## CALIFORNIA COASTAL COMMISSION

**A-3-MRA-19-0034 / 9-19-0918**

### EXHIBITS

SUBJECT: CalAm Monterey Peninsula Water Supply Project

Figure 30

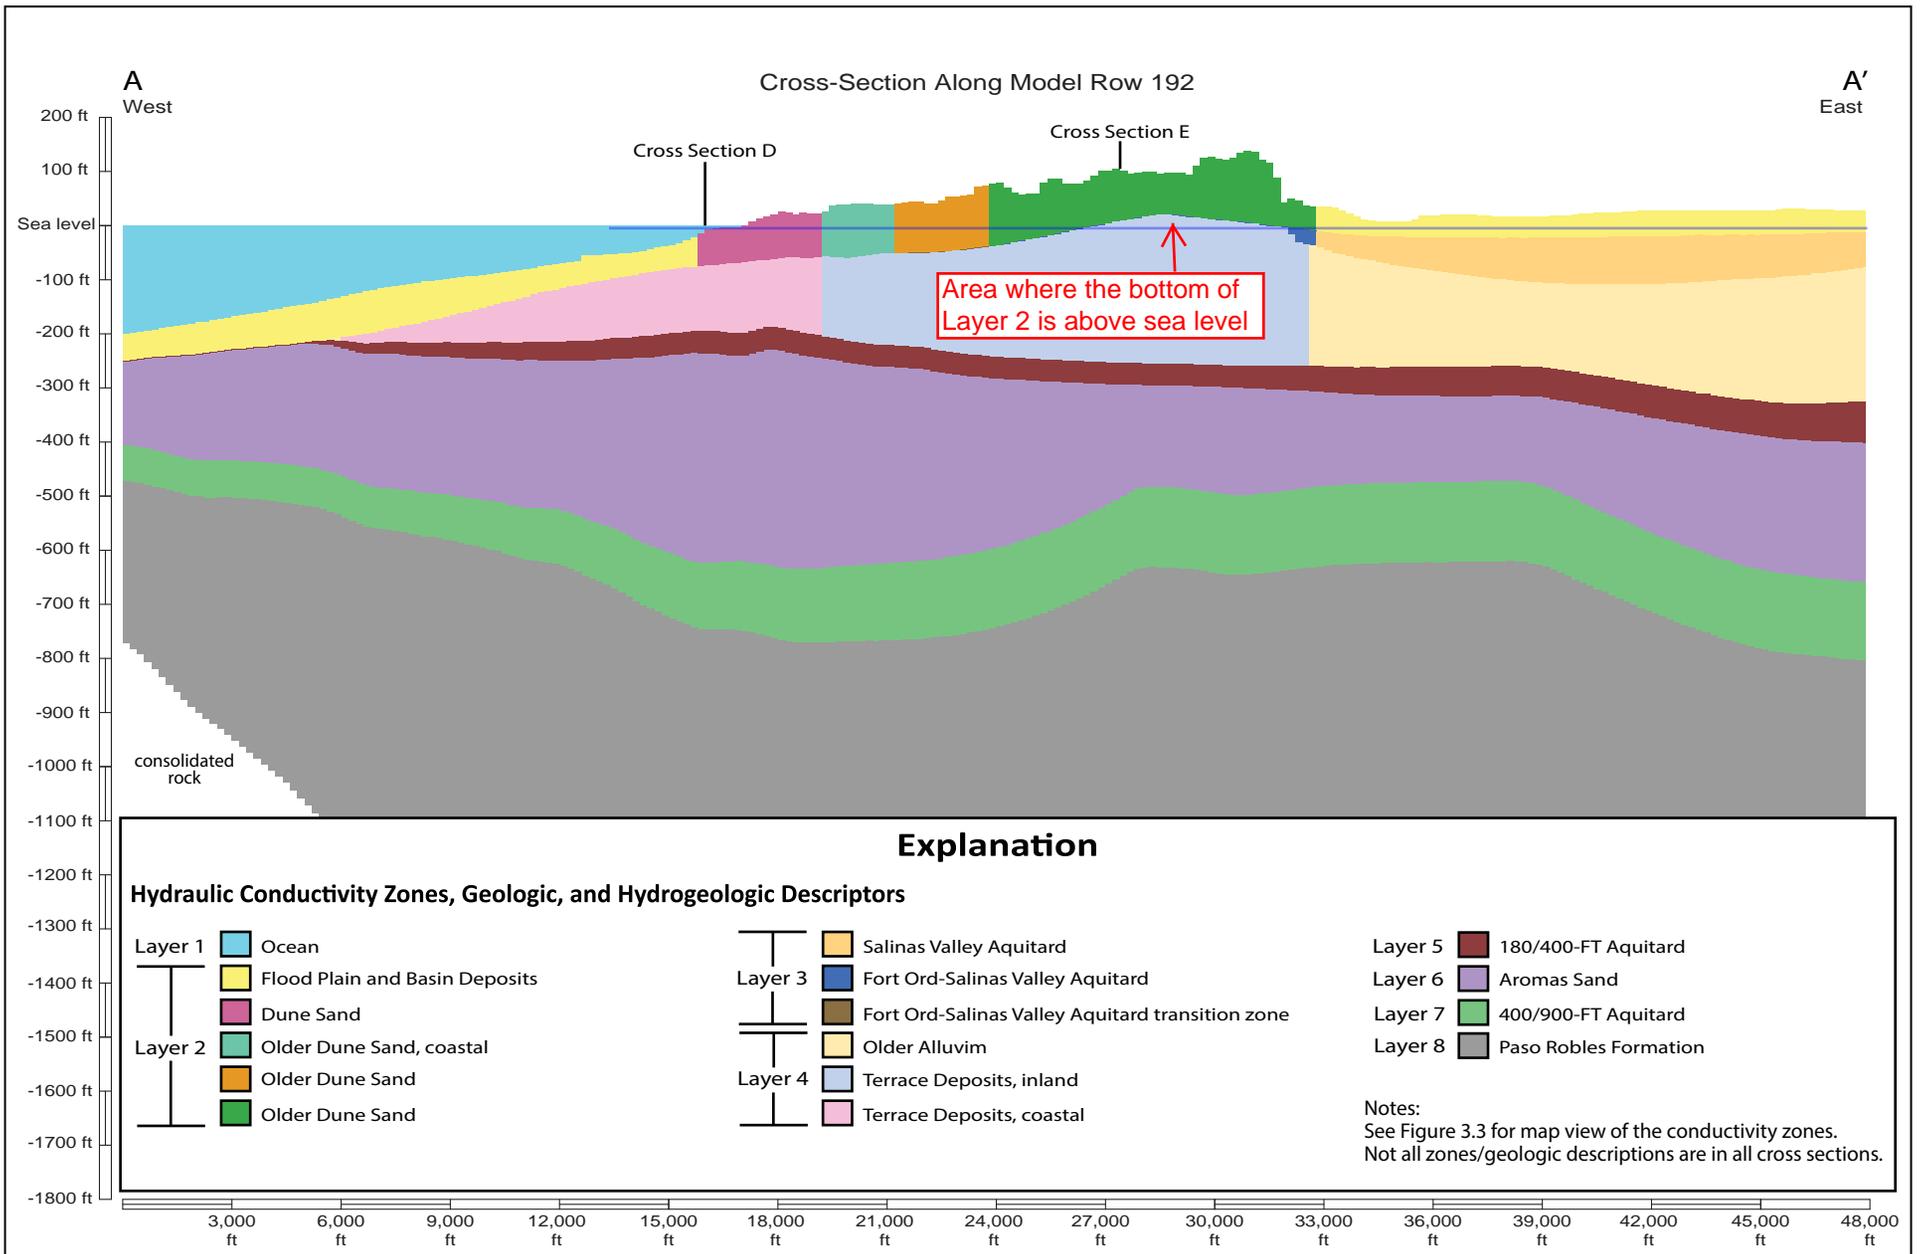
Another limitation of the superposition approach for Layer 2 is that initial water levels are set at zero, equal to sea level. As shown in annotated model cross sections A-A’, B-B’, and E-E’ (Figures 30, 31, and 32), this places the bottom of Layer 2 above sea level, above the initial head setting for the model, indicating it would be unsaturated. The estimated areas where this condition occurs is shown on Figure 33. However, superposition analysis results show physical inconsistencies, such as cones of depression that includes these unsaturated areas (Figures 34 and 35), and drawdown of 2 feet in well MW-5S (Figure 34), which is presumably screened in a perched aquifer zone hydraulically separate from the Dune Sand Aquifer. The only way these results could have been achieved with the superposition approach is that some modification to model layers must have taken place that was not documented, along the lines of lowering the riverbed in the example superposition analysis provided in Appendix E2 of the Final EIR/EIS (Attachment 1).<sup>(7e)</sup> The effects of such modification are not documented and cannot be evaluated.

With Flow Net and Additional Fresh Water Capture Area (grey shading)

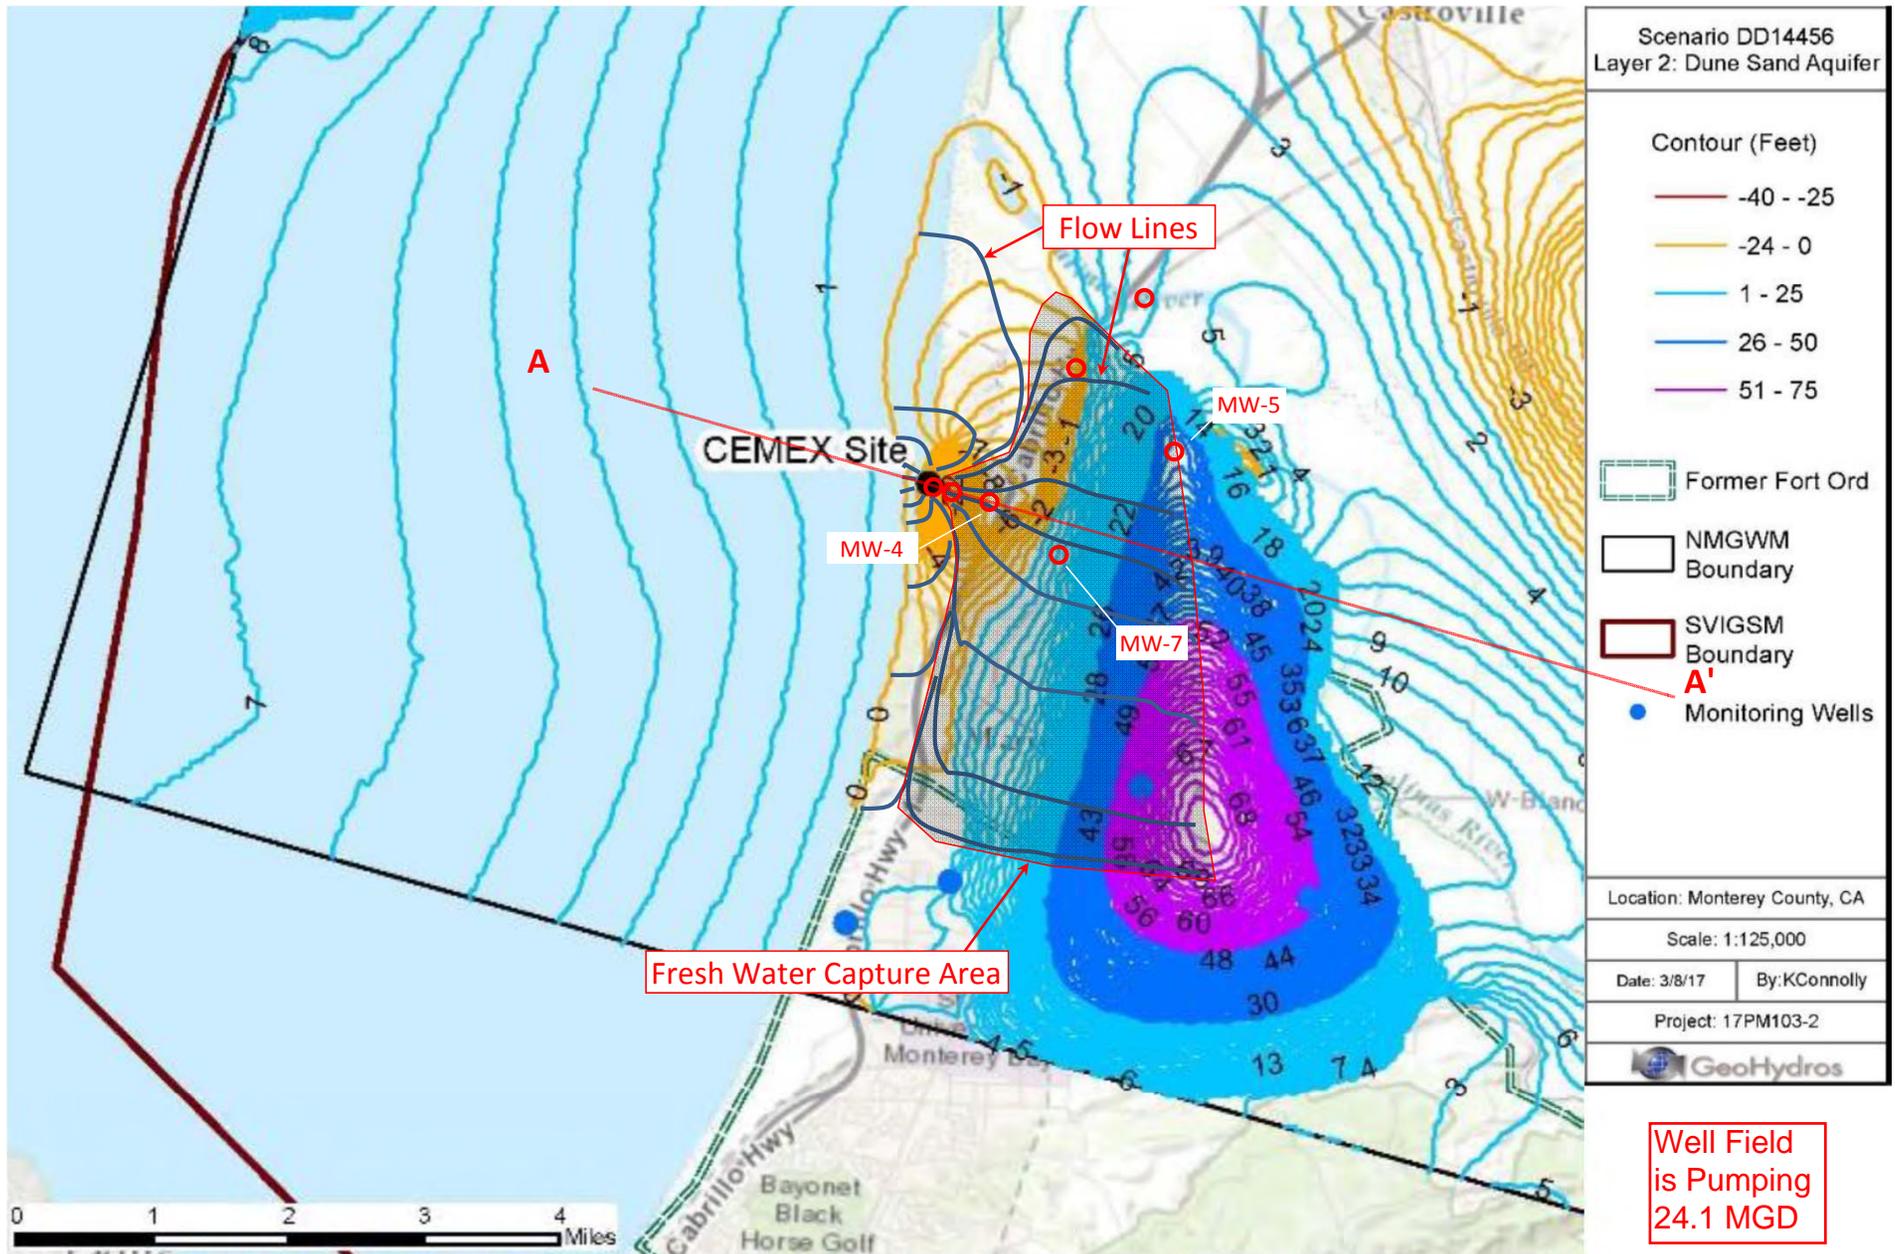
Additionally, Weiss performed a simplified flow net analysis using the contours generated to estimate the additional area over which fresh water would be captured by pumping (Figure 42) beyond the capture zones estimated for the Final EIR/EIS. This assumed area is approximately 7 square miles. Assuming annual average groundwater recharge of 5 inches per year (0.42 feet/year), as was done for the Final EIR/EIS OWP analytical estimates,<sup>(Appendix H of 7f)</sup> this results in a potential annual average capture volume of 1,900 acre-feet per year. Assuming a worst-case scenario where the well field was pumping at 15.5 MGD (equal to 17,360 acre-feet per year), and assuming an OWP from within the original capture zone of 96 percent from the Final EIR/EIS calculations, the additional captured volume equates to 1,900/17,330, or 11 percent. Subtracting this from the OWP of 96 percent provides an overall OWP of 85 percent.

However, this result is likely to be an underestimate of the true OWP, because it denies any flow of groundwater from the Dune Sand Aquifer to the 180-Foot Aquifer inland of the capture zone (approximately 2,000 to 4,000 feet inland of the pumping wells) defined by the Final EIR/EIS. The NMGVM<sup>2016</sup> (Figure 42) can also be used to generate a best-case scenario by estimating the horizontal flow towards the pumping wells through Layer 2, parameter Zone 20 (Figure 29). This layer has a hydraulic conductivity of 4 ft/day (Figure 27) in Zone 20. Given a conservatively high maximum seaward gradient of 0.0035, a length of Zone 20 of 4 miles perpendicular to the path of flow shown on Figure 42, porosity of 0.25, and a saturated thickness of 50 feet, the model can be estimated to produce a flow towards the pumping wells of only 30 acre-feet per year. This is because, as previously discussed, as modeled, most of the flow from Layer 2 is vertically downward to the 180-Foot Aquifer. This value is too small to have any effect on the original 96 to 99 percent estimated range in OWP calculated in the Final EIR/EIS and is likely to be unrealistically low.
